1977/43. Stability of a proposed subdivision Everton Lane area, Evandale.

Mr and Mrs A.G. Chugg requested a detailed examination of a block of land [EQ248018] which they propose to subdivide into two lots. Previous advice on the land was based on the original regional survey of stability in the Tamar Valley, undertaken some 5 years ago, and a more recent inspection of part of one of the lots. The majority of the land is classified in Classes 4 and 5 on the Landslip Zone Map of the Tamar Valley (fig. 1), with areas around Rose Rivulet classified in Class 2. This suggests that without detailed subsurface investigations and particular attention to drainage, only the lower lying and less attractive areas would be suitable for development as house sites. After a more recent inspection, small modifications can be made to these recommendations.

Figure 1. Location of proposed subdivision.

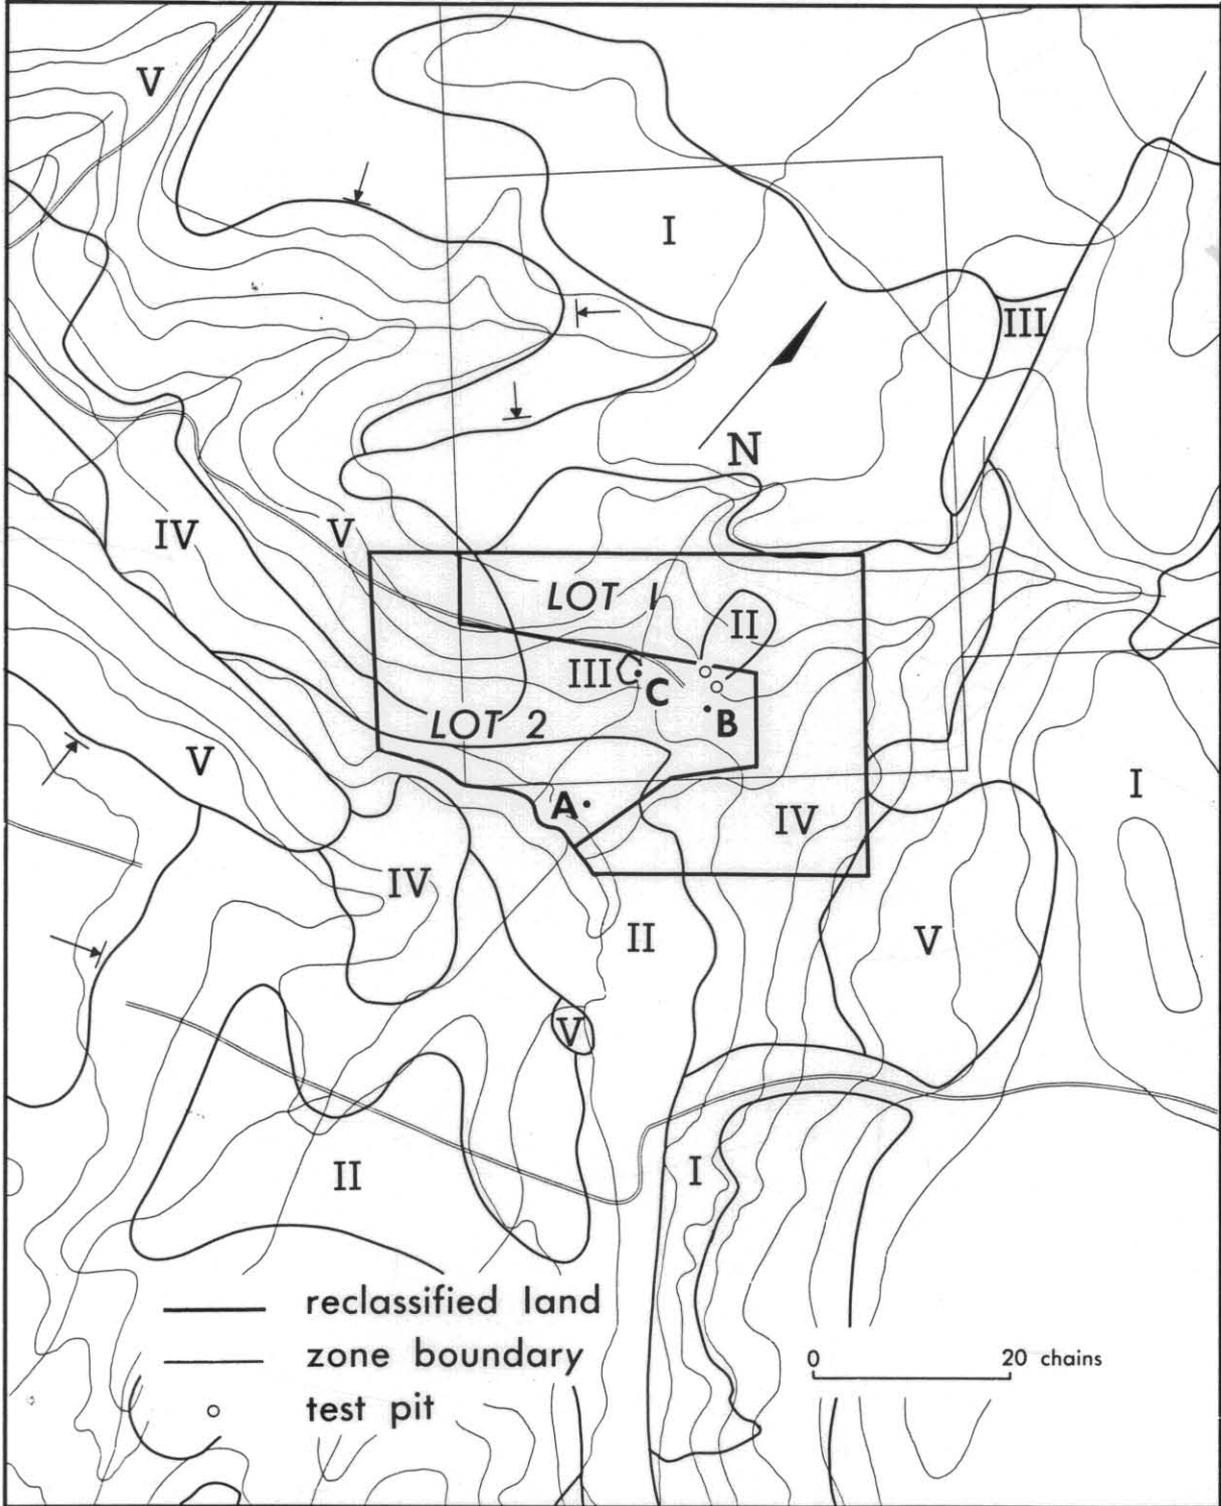
The area around Point A (Lot 2) on Figure 1 is already classified as Class 2 and a location near Point A could be used as a house site without any restrictions. This site is near Rose Rivulet on a low rise and would not be subject to flood. However it may not be a favourable position as far as access is concerned. Small scale subsurface investigations on Lot 2 may show that the areas surrounding Point B and C on Figure 1 are suitable for development. If either or both of these sites were shown to have favourable subsurface conditions for building, some special provisions should be made to disperse household drainage well away from the sites. These areas could be investigated with a back-hoe with 2-4 holes to a maximum of about 3 m deep in each area.

There is now an area defined on each lot that is classified as Class 2 on the Landslip Zone Map and which can be developed with reasonable safety. Points B and C on Lot 2 (fig. 1) are probably more attractive sites for access than Point A. If investigations indicate suitable subsurface

conditions, these may be considered as alternative house sites. Special household drainage procedures would have to be implemented if these sites were developed. Other sites on Lot 2 would be more costly to investigate.
